Addendum 82: Regulation No. 83

Revision 1- Amendment 4

UNIFORM PROVISIONS CONCERNING THE APPROVAL OF VEHICLES WITH REGARD TO THE
EMISSION OF POLLUTANTS ACCORDING TO ENGINE FUEL REQUIREMENTS

"Figure 1

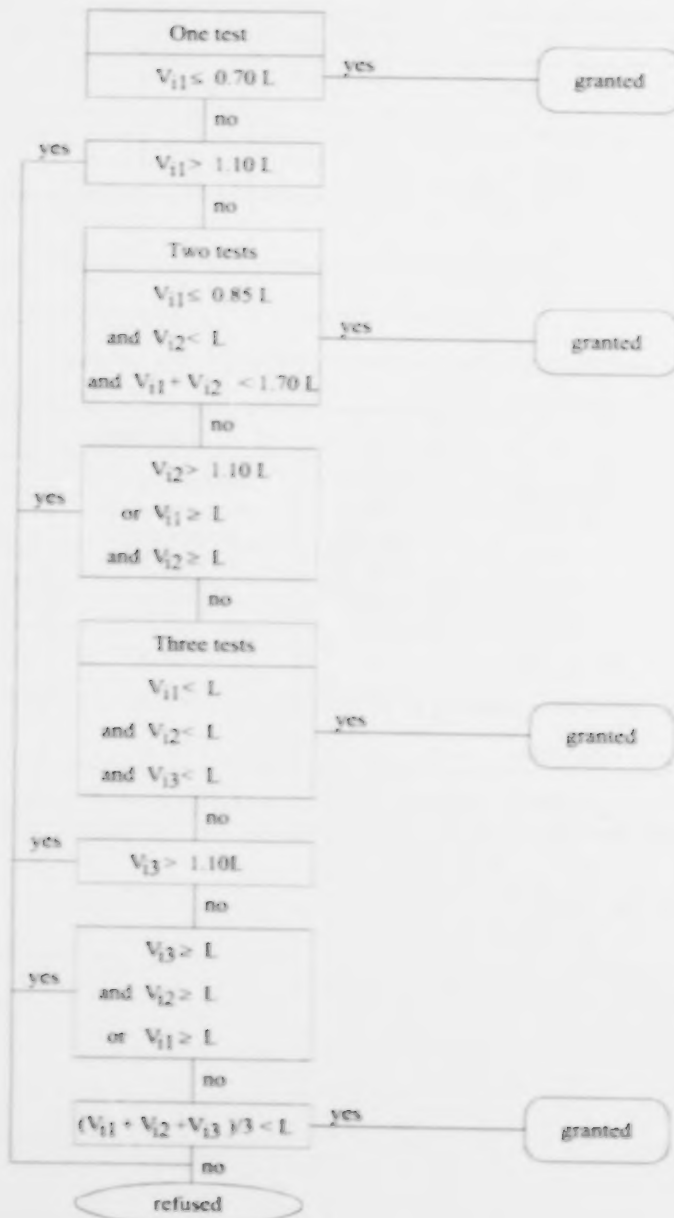
Figure 1, amend as follows:

Flow chart for the approval system type I tests

(see paragraph 5.3.1)

"Figure 2/1

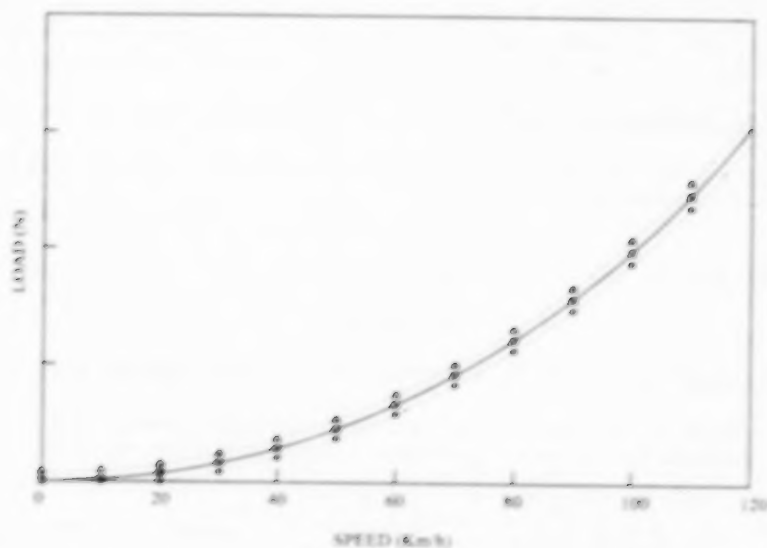
Figure 2/1, replace by the following figure:

Diagram illustrating the load of the chassis dynamometer

$$\square = F = a + b \cdot V \quad \bullet = (a + b \cdot V) \cdot 0.1 \cdot F_m \quad \Delta = (a + b \cdot V) \cdot 0.1 \cdot F_m$$

Figure 2/2

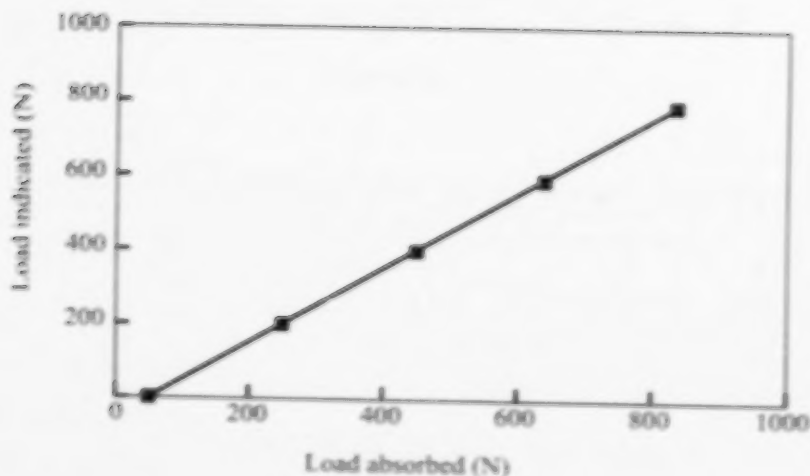
Figure 2.2., replace by the following figure:

"2.2.12. Figure 2/2 shows the load indicated at 80 km/h in terms of the load absorbed at 80 km/h."

Load indicated at 80 km/h in terms of the load absorbed at 80 km/h
